Docket Item # 4
BAR CASE #2009-0209

BAR Meeting
October 7, 2009

ISSUE: Signage
APPLICANT: Carr 625 First Street, LLC
LOCATION: 625 First Street
ZONE: CD/Commercial

Figure 4: Proposed Blade Sign Location

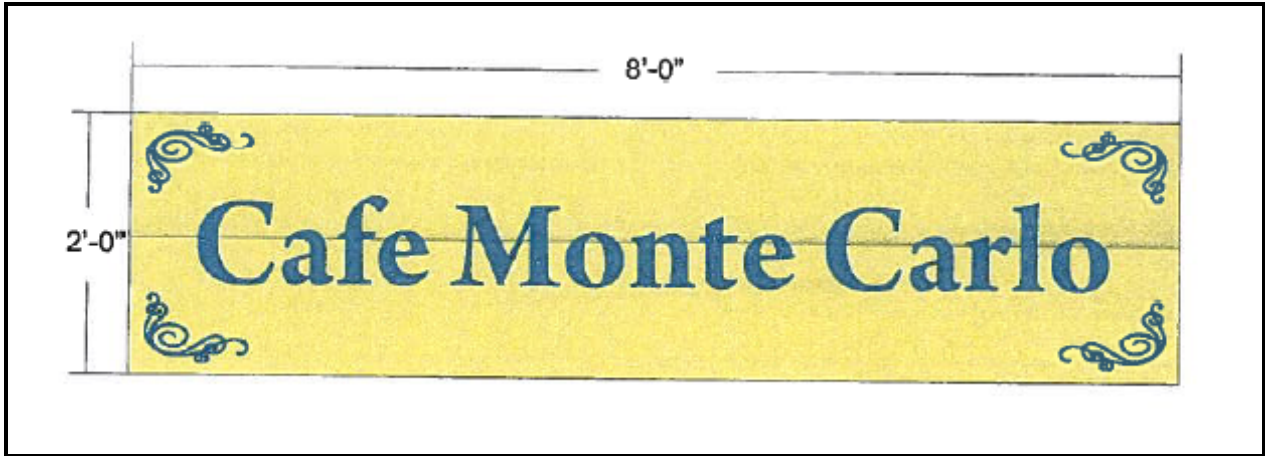
1. That the bracket and wall signage be mounted to the building through the mortar joints.

C-2 Projecting, hanging signs must comply with USBC [H103-H107, H112] for type of materials, maximum projection, vertical clearance below all parts of the sign, and additional loads.

Figure 5: Proposed Wall Mounted Sign

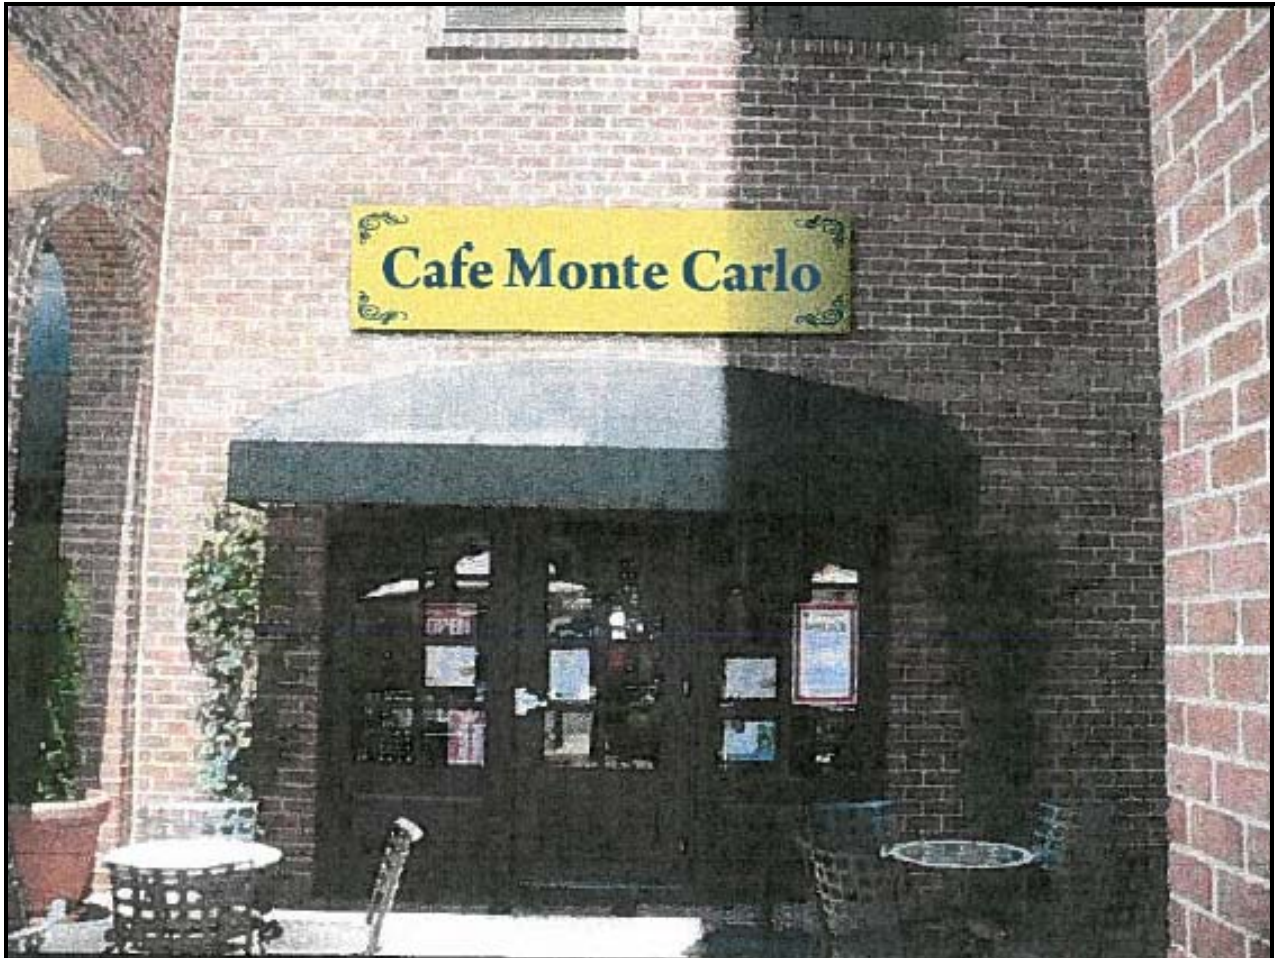
C-1 Wall letters / signs must comply with USBC [H103-H111] Please indicate the method to be used for anchoring the letters to the wall.
